Environmental Advisor
to the 1996
Olympic Games

May 7, 1996

Subject: Landfill Sideslope Subbase Design
Request for Alternate Procedure
Citrus County Central Landfill Phase 1A Expansion

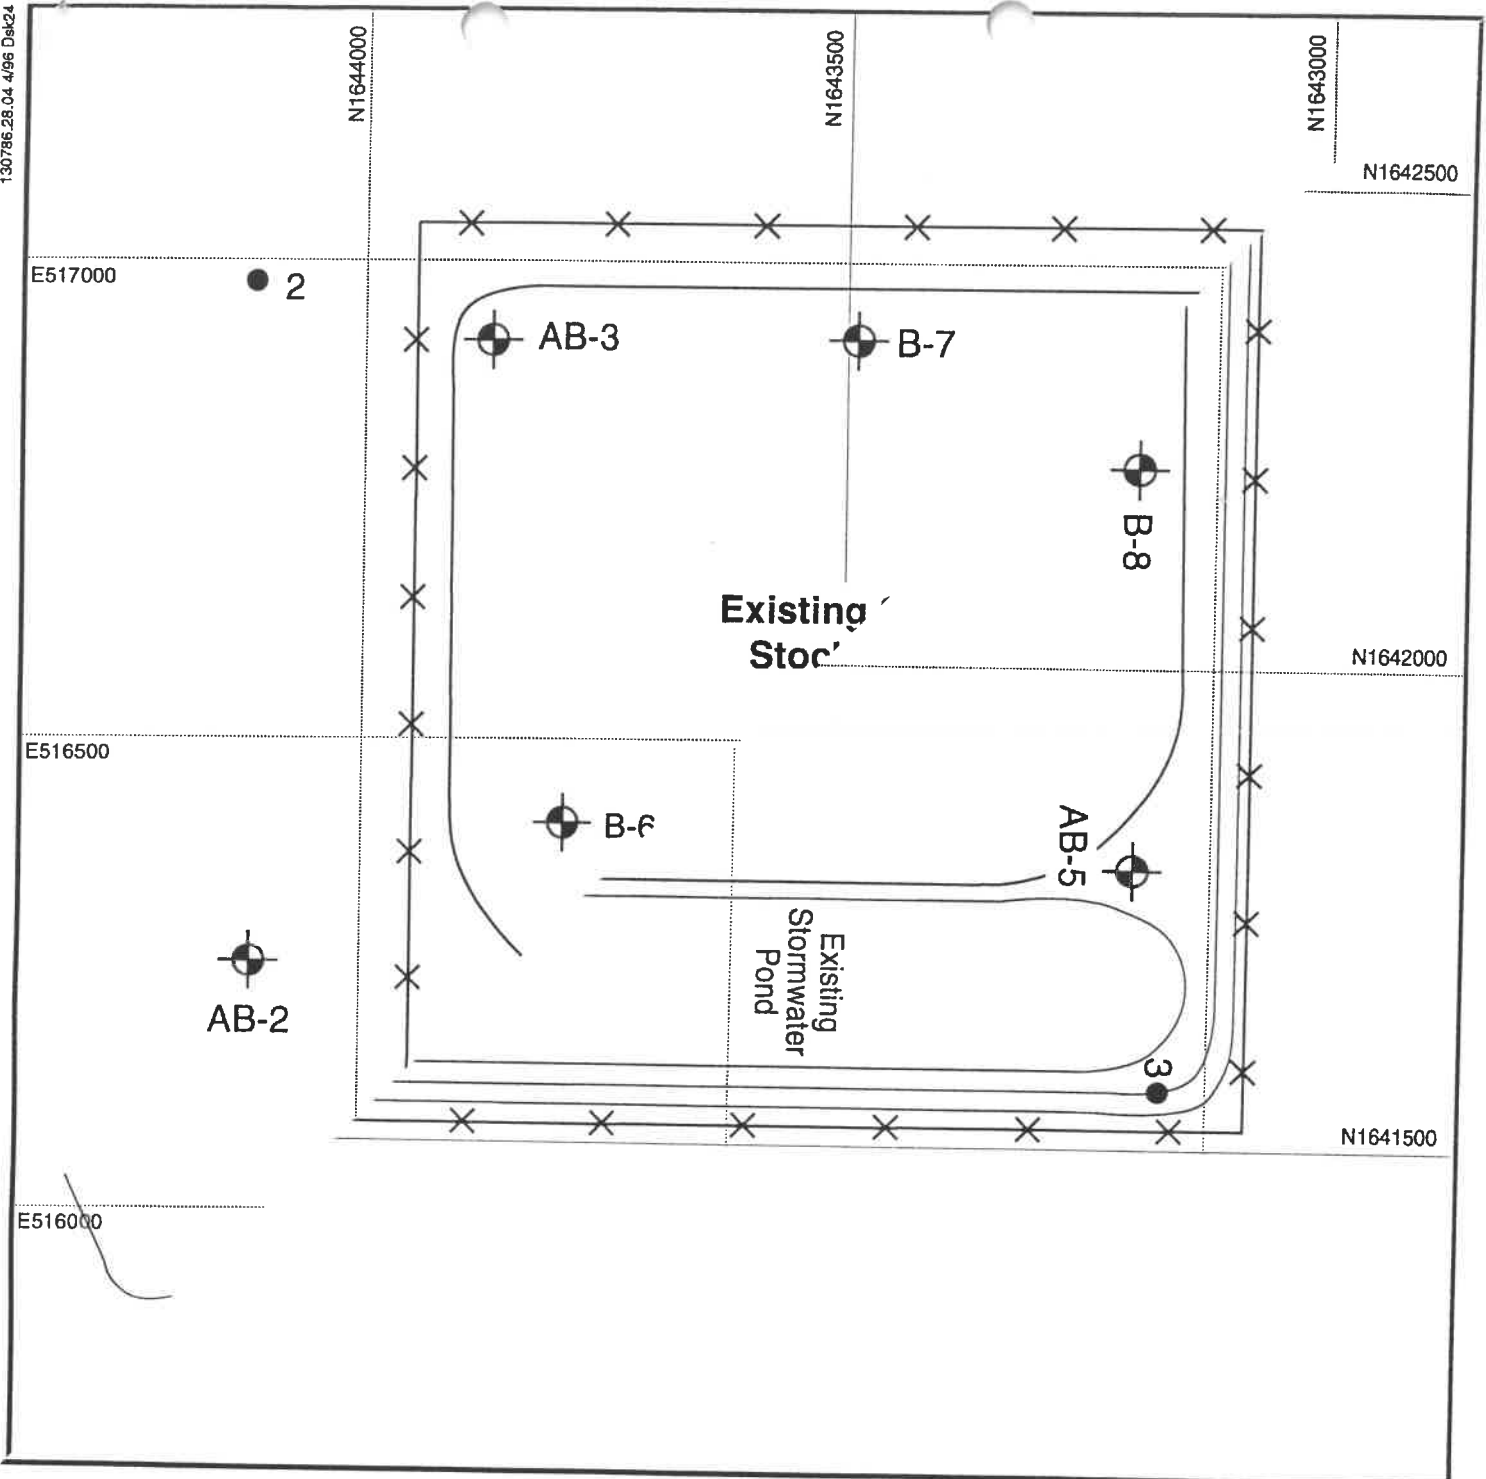
Request No. 1. Summarize existing hydraulic conductivity data and provide a figure with the locations of the exploratory test sites.

The locations of the exploratory test locations from the PBS&J, Universal, and CH2M HILL/Ardaman investigations are shown in Figure 1.

Response No. 2. On April 23, 1996, Citrus County personnel excavated two test pits (TP-1 and TP-2) to a depth of 7 feet below ground surface. The test pits were excavated on the east and west sides of the proposed Phase 1A Expansion approximately 35 feet north of the existing landfill (see Figure 1). CH2M HILL personnel visually classified the soil within the
